# Jhimruk Khola Intake

DESIGN OF INTAKE AND DESILTING ARRANGEMENT FOR  
THE JHIMRUK HYDRO-ELECTRIC PROJECT (NEPAL)

OCTOBER 1988

P. J. PLOOY

FIGURE 4.11

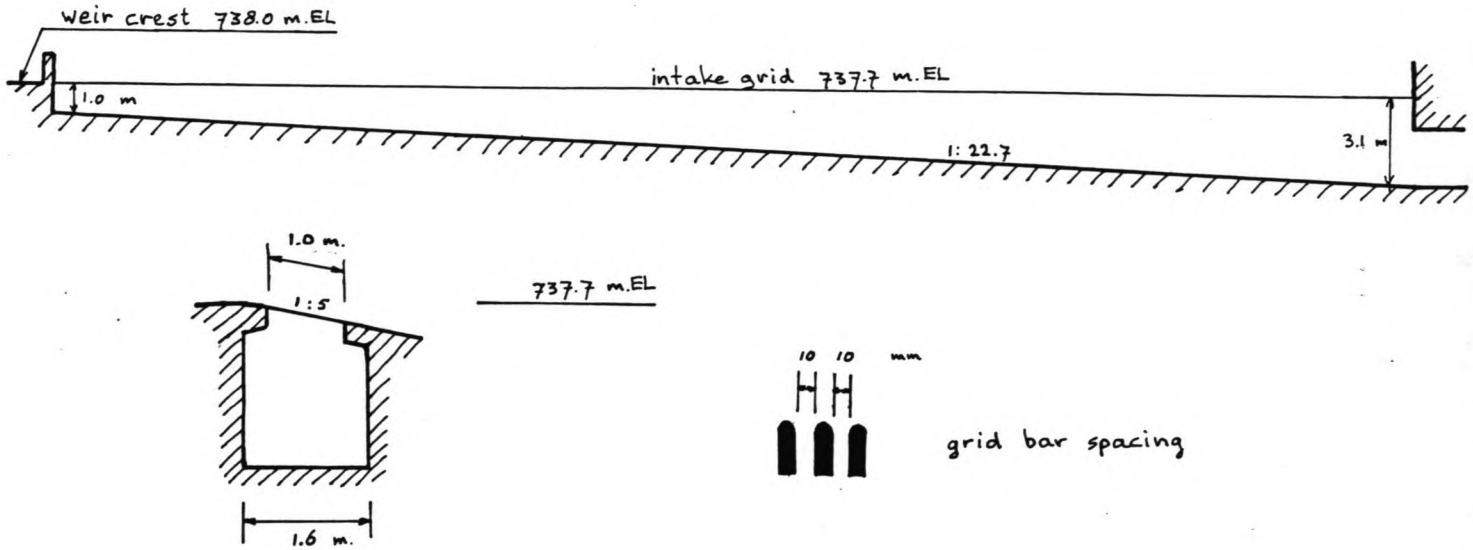
2. Any failure of the intake gate to close in response to the turbine demand will lead to excessive spilling out of the desilting basin on the Madi Khola side of the ridge.

The first problem would be acceptable if it would only mean that the sand had to be dug out of the trench once a year after the monsoon period. The plant operation and the river conditions are constantly changing however, and often very fast. Two days after a flood has filled up 80 % of the length of the trench the water level in the river can be so low that 50 % of the intake width is needed to catch the demand discharge <sup>1</sup>. This would mean that after every (serious) flood the intake trench would have to be cleaned in order to achieve sufficient intake capacity again.

FIGURE 4.16 Flow profile in collecting trench

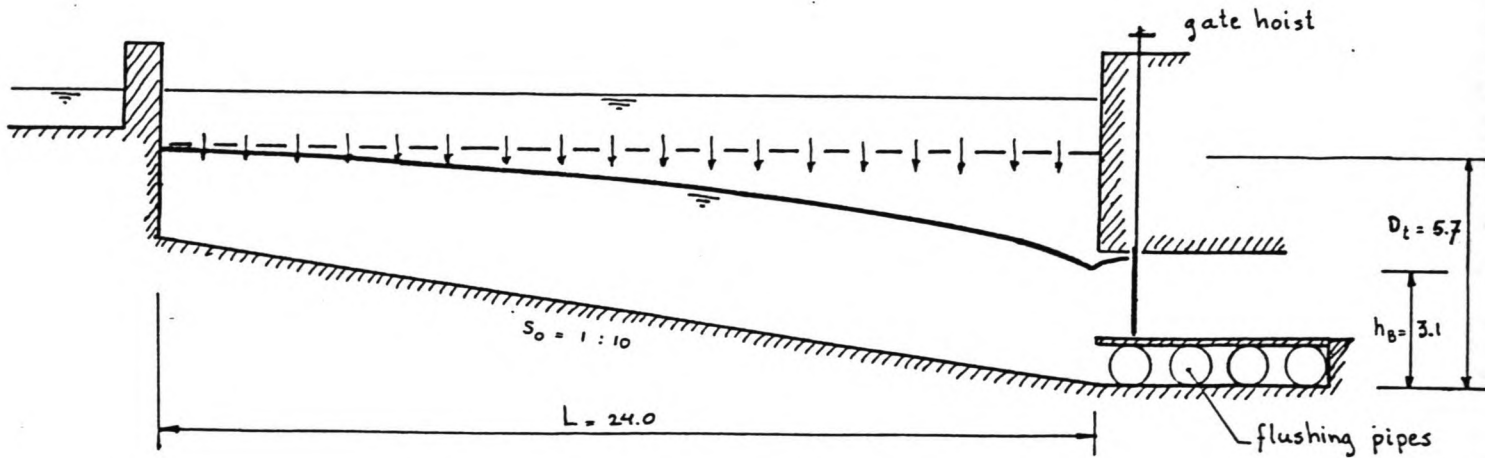
The total depth of the trench  $D_t = 5.7$  m. below the intake grid. The grid level must therefore be set at  $734.5 + 5.7 = 740.2$  m.. This implies raising the weir with 2.5 m., since the grid level in the NEA design is only 737.7 m.EL.
